PLANNING AND ZONING BOARD STAFF REPORT

Delray Beach Water Treatment Plant

Meeting	File No.	Application Type
January 26, 2026	2025-118	Level 3 Site Plan
Property Owner		Authorized Agent

Request

Proposed Site Plan

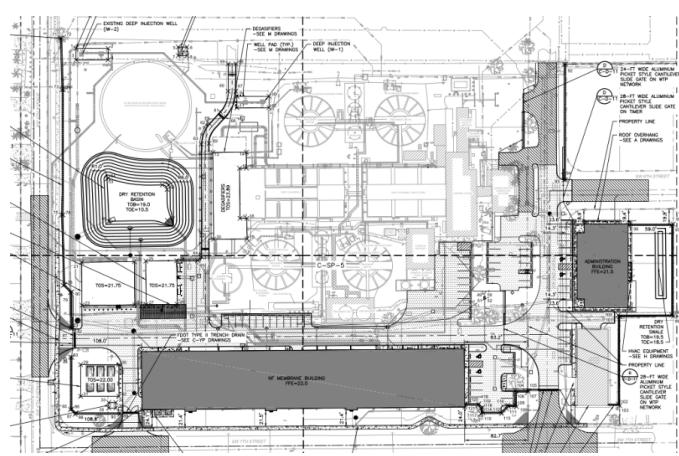
The Site Plan was reviewed according to the performance standards for site plan actions listed in **LDR Section 3.2.3** and these standards have been factored into the technical review of the application. The intent of the standards is to ensure that certain essential criteria and a level of quality are adhered to with regard to new development. The project complies with the performance standards.

The proposed project has been reviewed by the Technical Advisory Committee and has been deemed technically compliant with all applicable regulations of the Land Development Regulations. No relief is needed to accommodate the proposed site configuration or building design. **LDR Section 4.3.4.(K)** establishes that the **CF** zoning district is not subject to any minimum setback regulation other than a 10' perimeter buffer, which – according to **LDR Section 4.4.21(H)(2)** - shall be increased to 15 feet or a decorative wall or fence shall be used when **CF** properties are adjacent to residential zoning districts. As such, a perimeter buffer of at least 10 feet has been provided, exceeding the minimum in most areas where a 21' building setback is proposed along the south property line adjacent to SW 7th Street and a 19' setback has been proposed adjacent to SW 6th Street. In addition, a decorative wall and landscape buffer has been provided along the perimeter where adjacent to residential zoning districts.

Parking has been assessed using the required parking for administrative office uses per **LDR Section 4.6.9** and has been assessed only for the portion of the new structures that contain office and lab square footage. Building area used for the housing of mechanical and utility infrastructure equipment has not been assessed parking. In total, the project generates 55 required spaces and 61 are provided, therefore exceeding the amount of required parking.

The maximum allowable height in the **CF** district is 48 feet, and both buildings are single story structures well below the minimum threshold. The maximum Floor Area Ratio in **CF** is 1.0, and with the proposed additional square footage the site still remains well below this threshold given the significant size of the total lot area. The proposed additional square footage minimally increases the existing FAR by only 0.11.

Review & Analysis: Landscape Plan

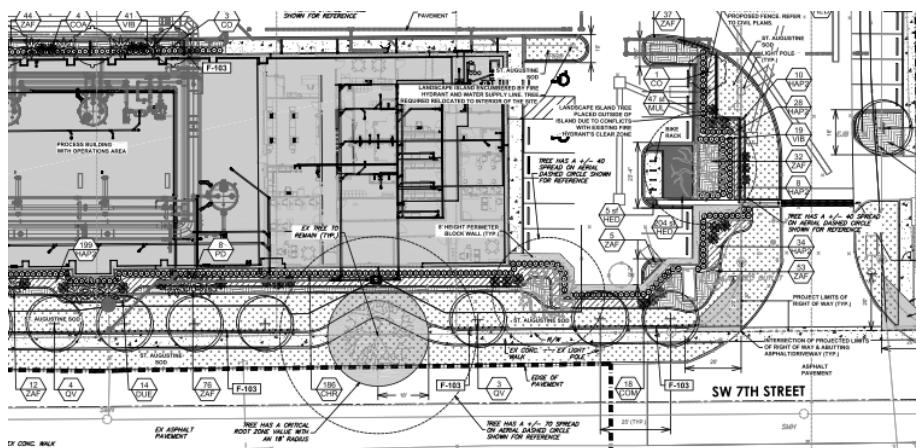
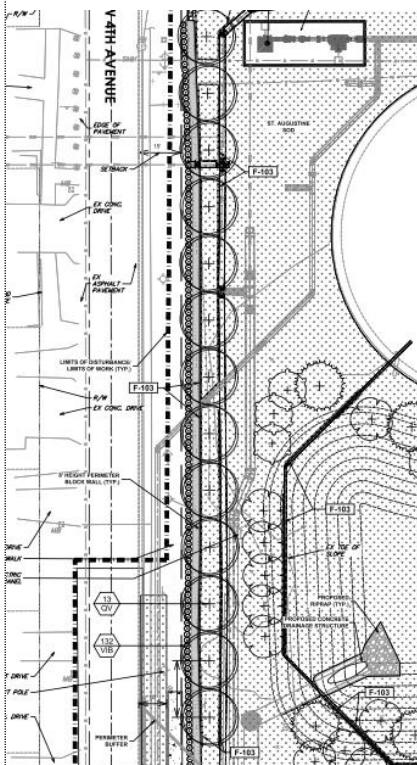
A technical review of this site plan has been performed, and a determination has been made that the project complies with all applicable landscape regulations. Landscaping is interspersed throughout the site such that the visual appearance of the treatment facility will be greatly improved. Foundation landscaping is provided along the base of the new buildings and within parking islands in areas where parking lots are being added or modified. Crucially, a substantial tree canopy is proposed along the property line adjacent to perimeter streets to provide beautification and screening of the facility, specifically, a continuous tree canopy of live oaks is proposed along each property line adjacent to a street (as shown in below images).

In total, 757 DBH of tree trunk is proposed to be planted, whereas 489 DBH of existing trunk diameter will be removed. The number of new trees proposed far exceeds the minimum amount necessary for mitigation; some existing mature trees will remain where feasible.

Review & Analysis: Architectural Elevations

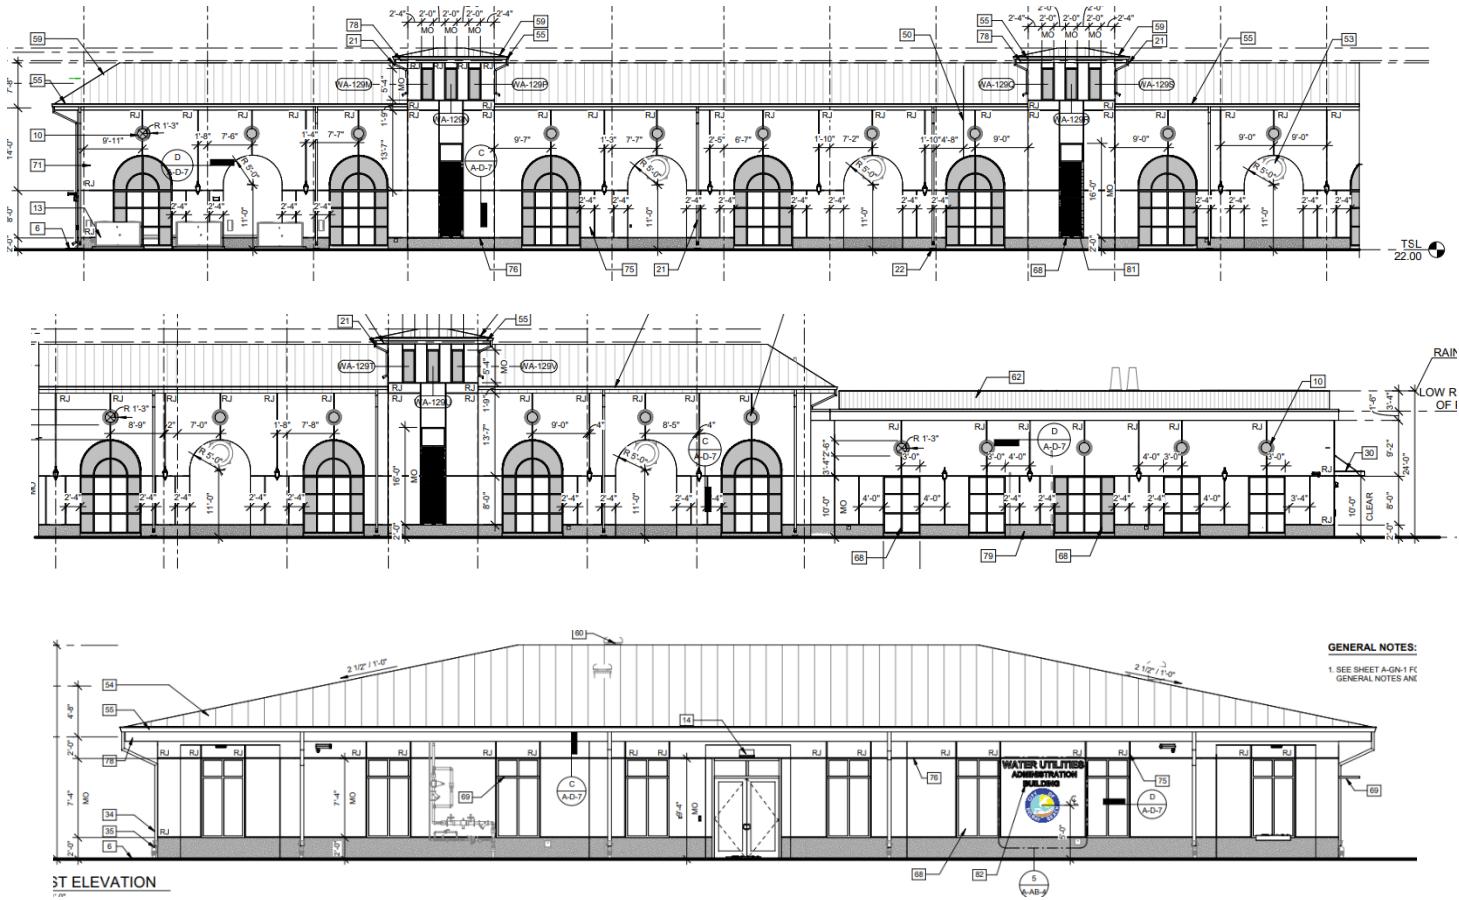
Staff finds that the design criteria are met. The design of the new buildings is stylistically appropriate for civic facilities, shares similar architectural reference to existing municipal structures throughout the city, is compatible with the coastal Florida architectural climate, successfully screens and mitigates the industrial and functional nature of the use through thoughtful architectural screening, and is presented at a scale that is fully consistent with adjacent residential neighborhoods. It is important to note that each building is less than 35 feet in height, which is the maximum height for single family residential zoning districts.

In addition, the design of the process building specifically – which extends for the largest portion of the street frontage – has been enhanced through the integration of vertical articulation, prominent window openings, tower elements, and other design details that introduce movement across the lengthy façade.

Importantly, consideration has been given in the design to ensure that the operations that occur within the process building on a 24-hour basis will not negatively affect the surrounding area (i.e. noise pollution, light spillover, etc.).
